CR167 – Oil Cooler Replacement

Panigale V4 - Panigale V4 S - Panigale V4 Speciale
Safety Recall Campaign SRV-RCL-18-006

Date: December 13, 2018
To: All required parties in descending order, Dealer Principal, General Manager, Service Manager, North American Dealer Network
From: Richard Kenton, Technical Director
Matthew Feinstein, Regulatory Compliance Manager

Part no.	Description	Photo	Quantity (pcs)
54811364A	Oil cooler		1

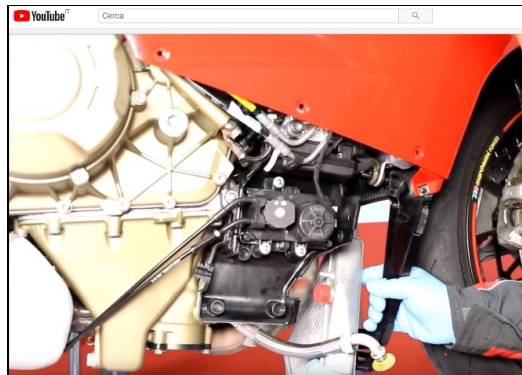
The solution developed is to upgrade all affected bikes of this campaign and replace the oil cooler. The new part no. 54811364A is characterized by two reinforcement plates at the fitting points of the oil delivery and return hoses as shown in the figure.

- 6.1 Take the new oil cooler (A) part no. 54811364A, characterized by two reinforcement plates installed at the fitting points of the oil delivery and return pipes as shown

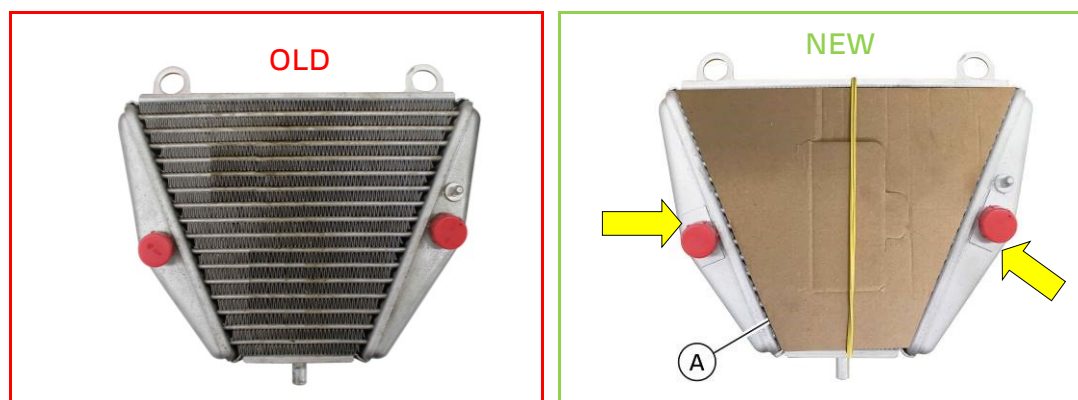
Do not remove the two front and rear protections present on the oil cooler. This packaging is to protect the oil cooler fins and avoid damage during assembly
